INDESIT company

BAN34PS

F034195

51520P0 Exploded views

N1030093fig1

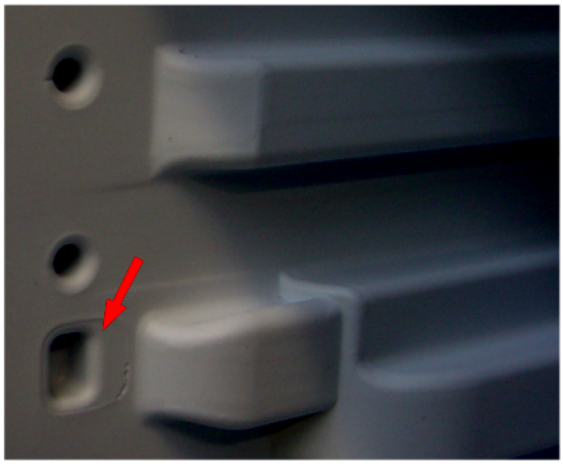
n1030093: New fixing of evaporator on static fridge-freezers (05 range) 60 cm,Melano

From August 05 (serial no. 50802.0001) the freezer evaporator is secured to the cabinet by a plastic profile.
The cabinet walls have been modified to create locations to house the profile, which is installed on the front of each evaporator plate (see photo N1030093fig1- fig2 - fig3)
The profile cannot be fitted on premodification appliances, so technical personnel must continue to fit the rh and lh supports on these models (see photo N1030093fig4)

New parts
C00141135 = WHITE PROFILE L=443.5 MM

Parts replaced
C00075596 = EVAPORATOR RH SUPPORT
C00075597 = EVAPORATOR LH SUPPORT

N1030093fig1

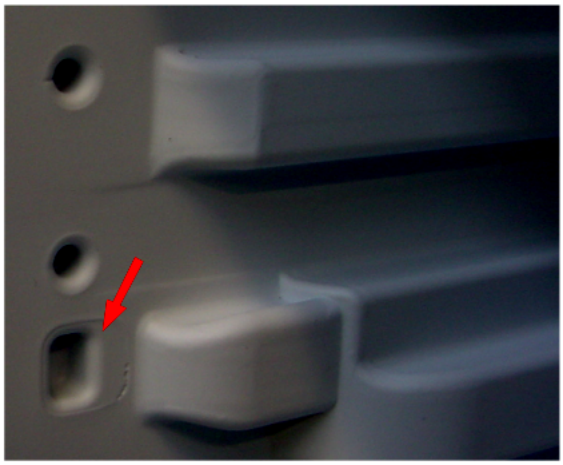
n1030094: New fixing of evaporator on static fridge-freezers (05 range) 60 cm, Lodowek

From August 05 (serial no. 50820.0001) the freezer evaporator is secured to the cabinet by a plastic profile.
The cabinet walls have been modified to create locations to house the profile, which is installed on the front of each evaporator

plate (see photo N1030093fig1- fig2 - fig3)
The profile cannot be fitted on premodification appliances, so technical personnel must continue to fit the rh and lh supports on these models (see photo N1030093fig4)

New parts
C00141135 = WHITE PROFILE L=443.5 MM

Parts replaced
C00075596 = EVAPORATOR RH SUPPORT
C00075597 = EVAPORATOR LH SUPPORT
